COOLANT HOSE CLAMP RE-TORQUE

Prevost vehicles

On the vehicles affected by this bulletin, re-torque the clamps on specific coolant hoses of the cooling system.

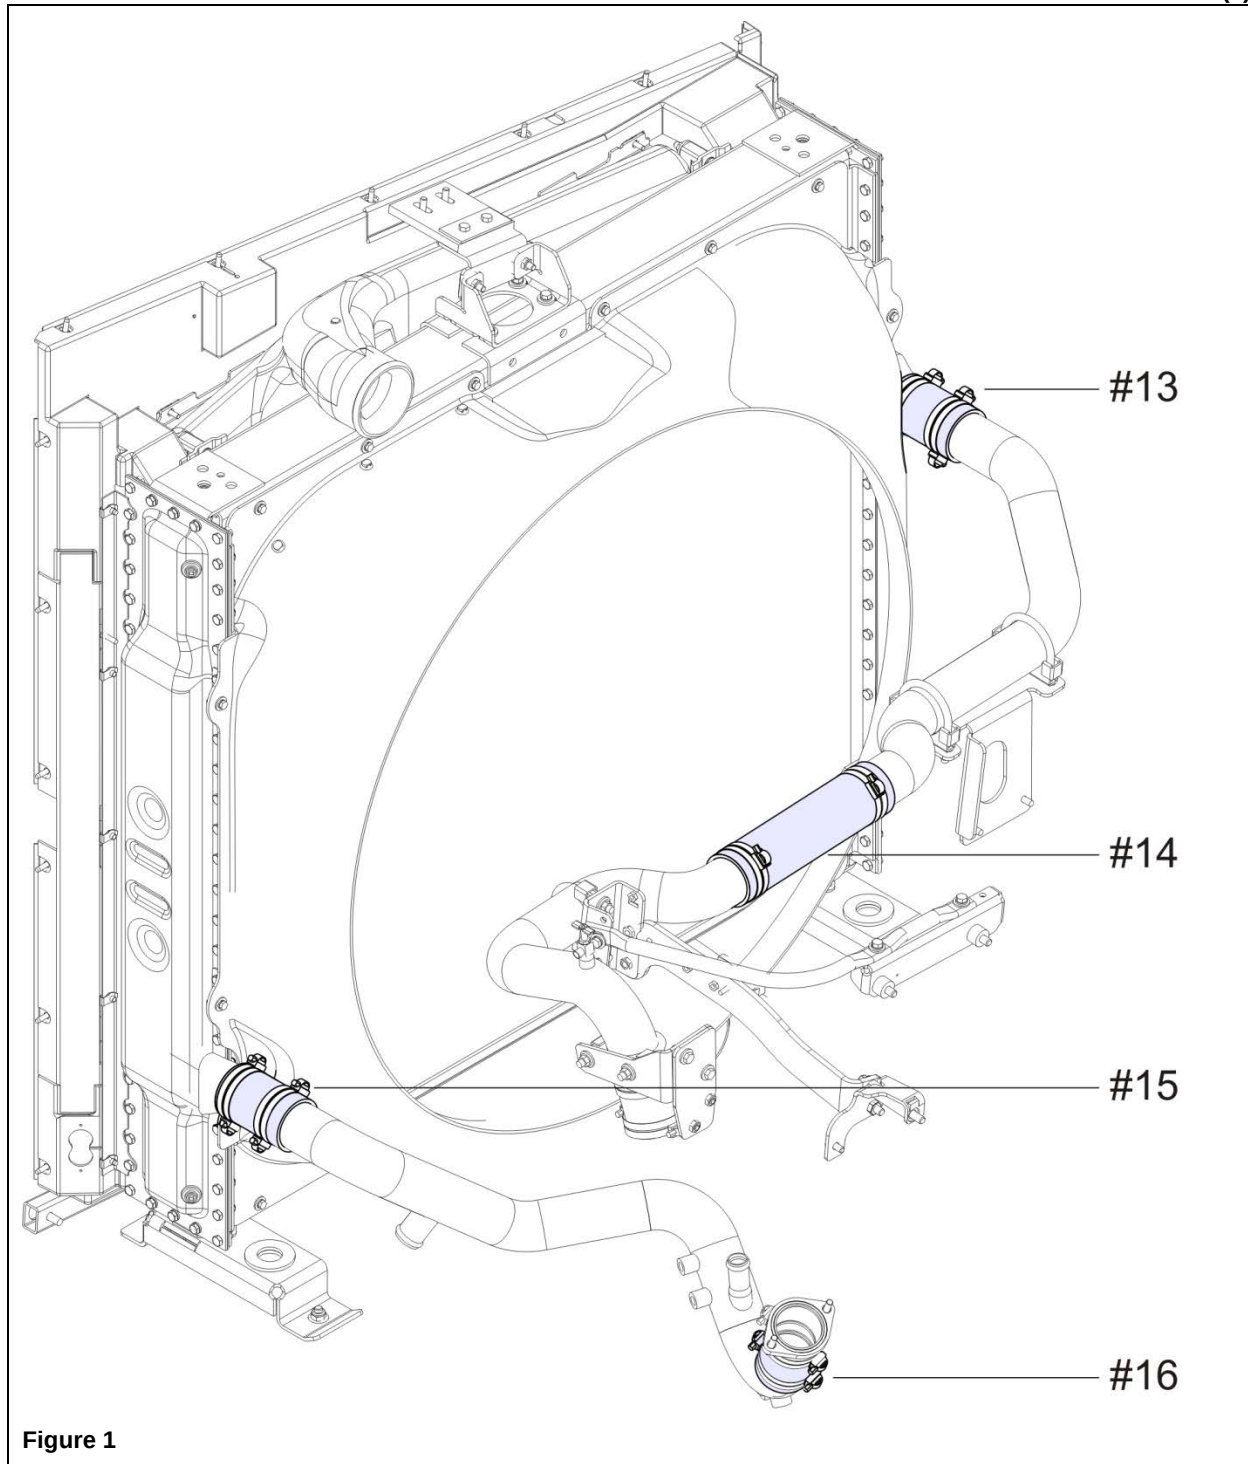
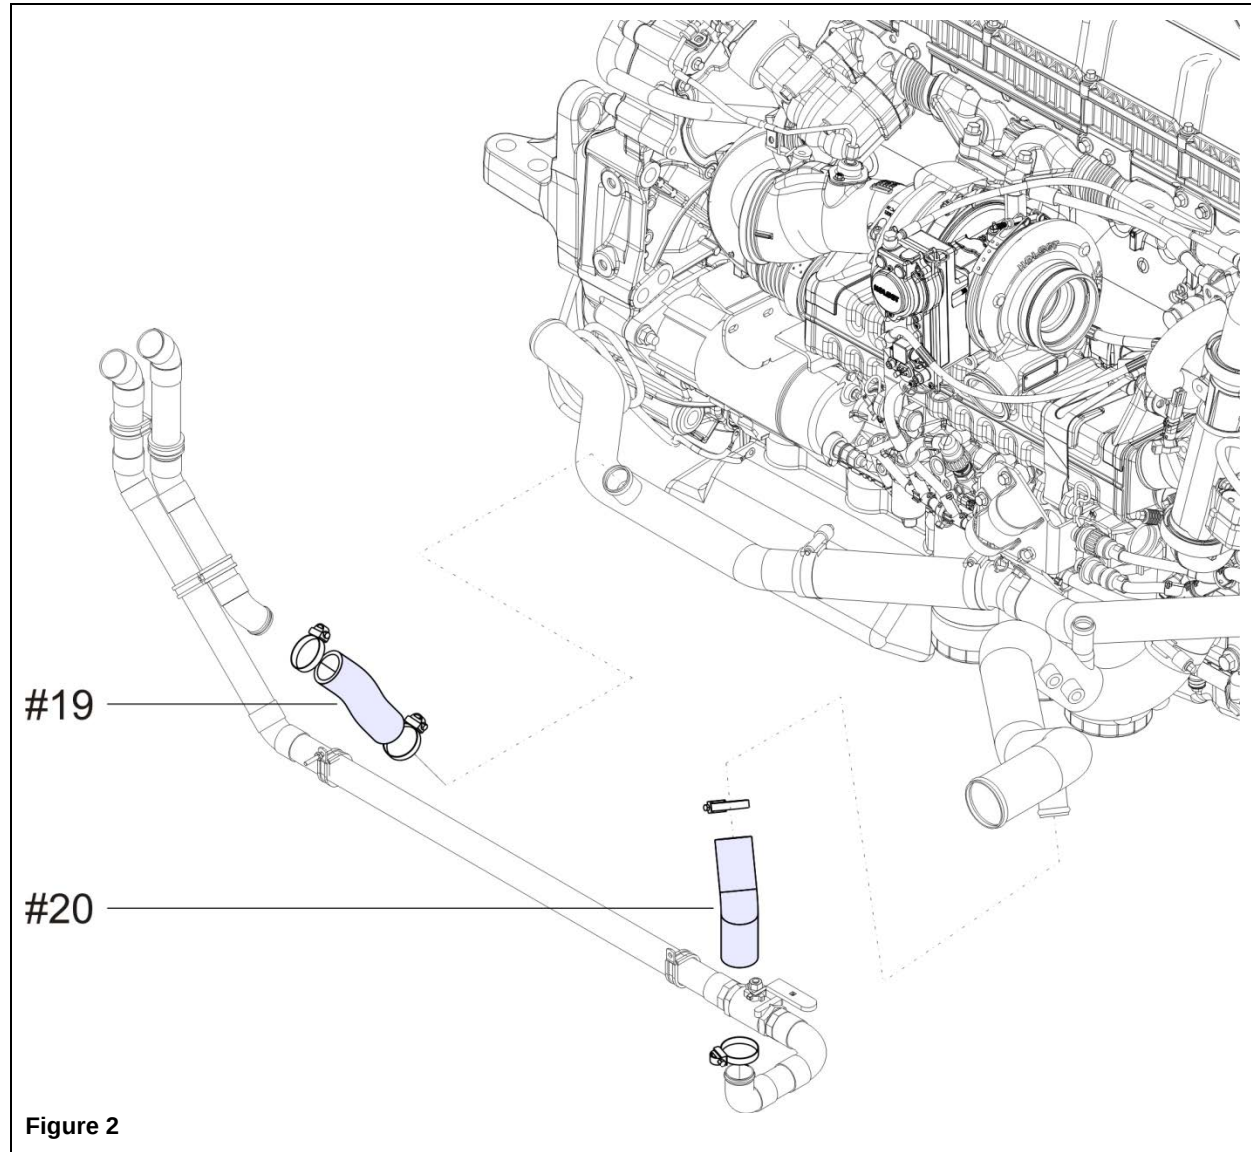
1. Lift vehicle with mobile column lifts.
2. Locate flexible hoses below and re-torque clamps to 30 lbf-in. (Fig. 1 & 2)
3. Apply torque seal after tightening.

If a clamp is found to be defective and requires replacement, it should be located on the hose in the same seat position as the original clamp.

Figure 3: Hansen coupling on surge tank.

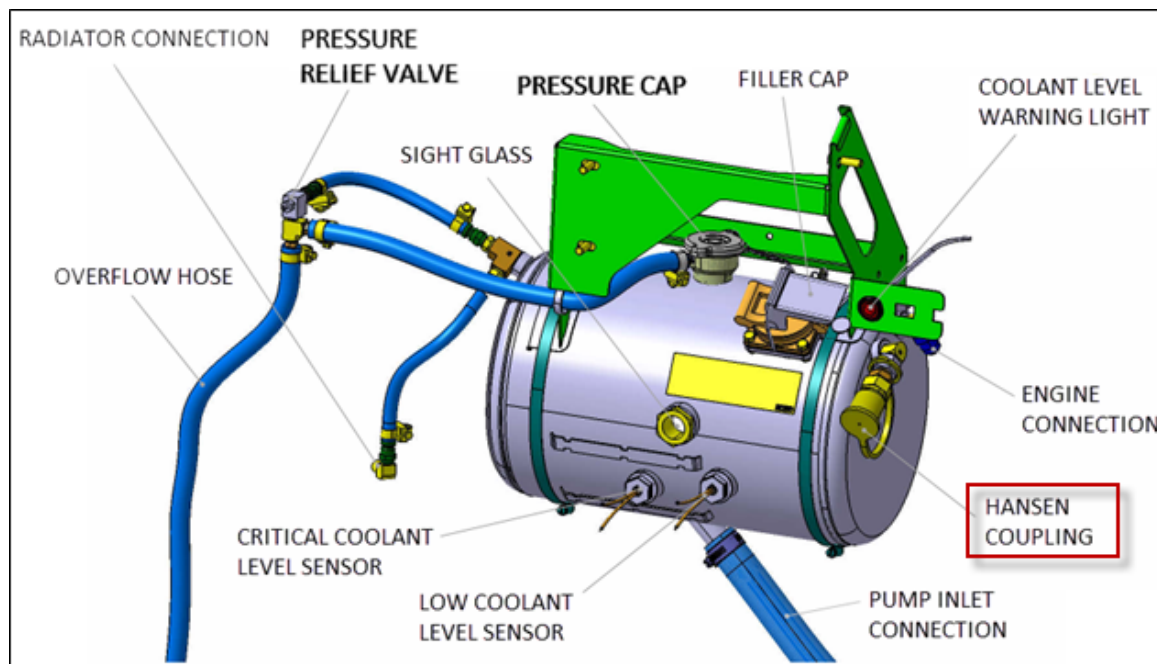
- Re-pressurize the system by the "Hansen" coupling. (Fig. 3) Do not exceed **15 psi**.

- Check for any leaks.
- Return battery master switch to the "ON" position.
